Seattle Design Commission

MINUTES OF THE MEETING

20 January 2005

20 Jan 2005 Project: Olympic Sculpture Park

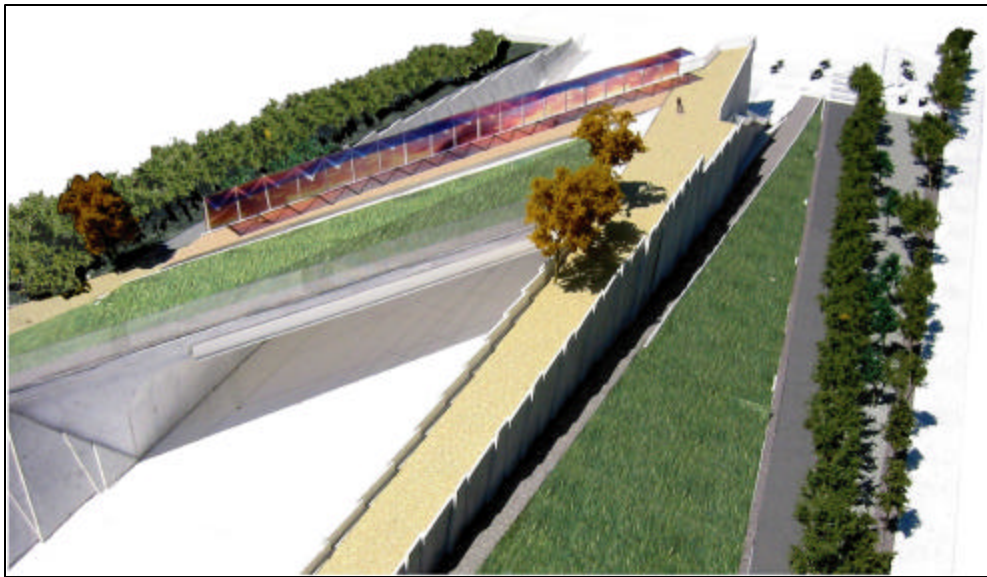
- Asks for clarification of parking currently on Elliott
 - There is no parking on the block of the park. There is currently parking south of Broad Street and one block north of the park.

- Asks where art will be located under bridge and if it will be permanent.
 - Nothing is entirely permanent and nothing is slated for the opening. There is the possibility for video works but nothing has been determined.

- Asks if SDOT would be concerned with driving and video art under the bridge
 - We would have to evaluate that risk and discuss with SDOT
- Asks for clarification on lighting it would be in addition to street lighting required by SDOT

- Asks what is on wall of bridge coming south of Elliott in car
 - Signage for park
- Asks proponents if they have any safety concern with the meadow sloping down on the west side to Elliott to street where there is no parking buffer between street traffic and the park space.

- No it is gentle 4 to 1 slope and there is a couple of feet buffer and a 12' wide sidewalk before reaching the curb
- Asks what is the width of the bridge deck.

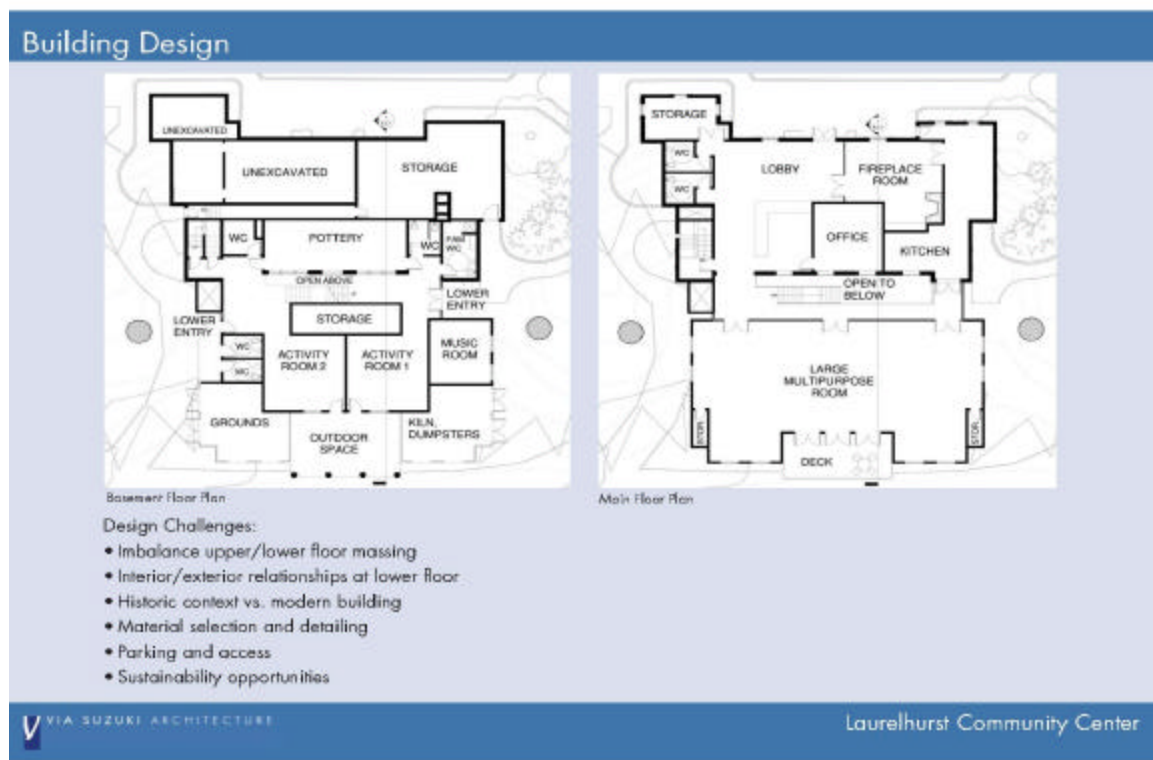
- Questions the use of partial dividers in the existing grand multipurpose space
- Questions the location of the elevator
- Questions the use of glass as a breezeway connector, suggests using wood as a material

- Suggests making roof higher on proposed building to achieve added volume
- Suggests moving elevator
- Suggests using glazing at ends of the breezeway and a full roof

The proposed design is based on option #3, and it includes a 20' breezeway to connect the buildings.

Montlake Community Center Expansion Site Plan

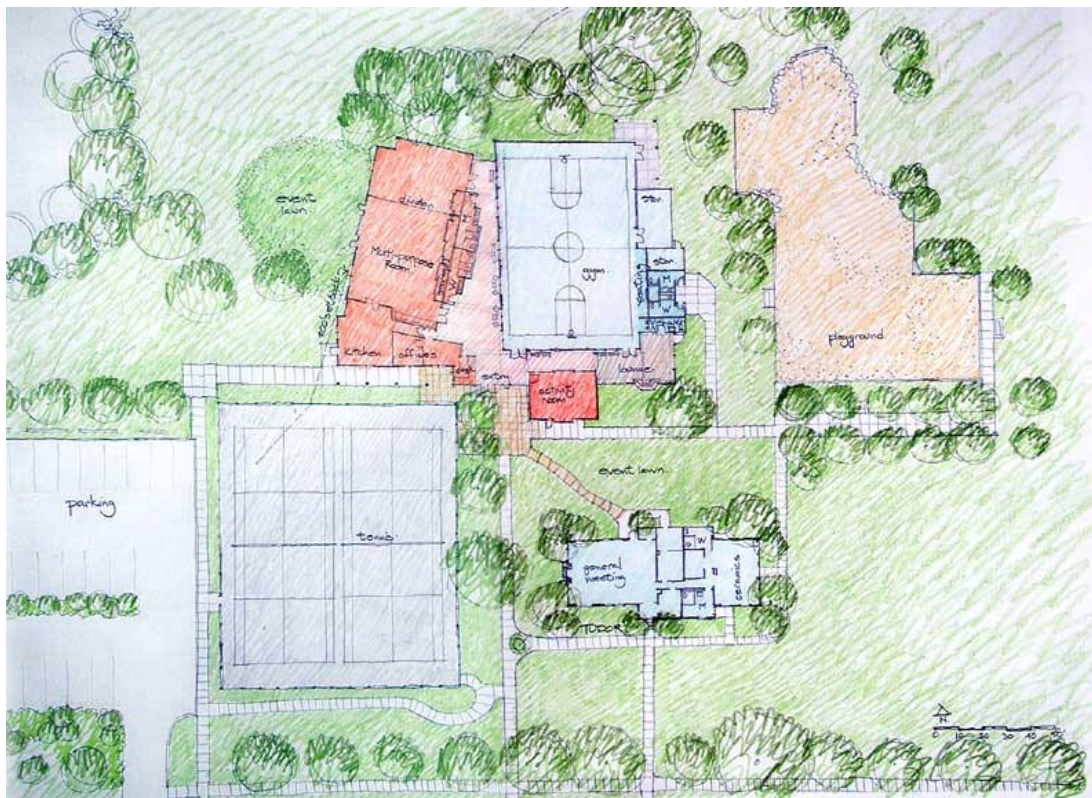
- Appreciates proponents' decision to give the Tudor building room
- Questions the placement of the walkway between the Tudor building and field house area

- Questions the location of the activity room.
- Recognizes that the connection between the buildings and the parking lot is not ideal, but realizes that there is not much that can be done to improve it.

- Appreciates how porous the project is inside between the gym and the other spaces, as well as outside between the buildings and the landscape.
- Encourages proponents to clarify and rationalize the path system

Montlake Community Center Expansion West Elevation

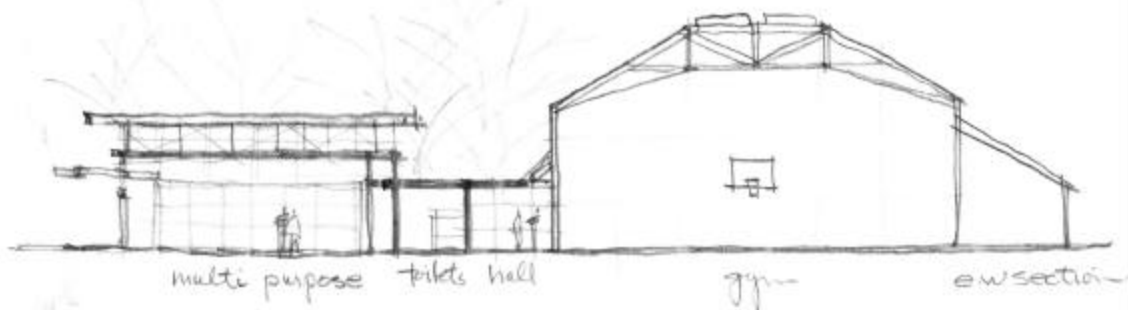
- **appreciates how the subtle façade of the community center is respectful to the Tudor house, but then becomes more lively and exciting out back, moving west around the building.**
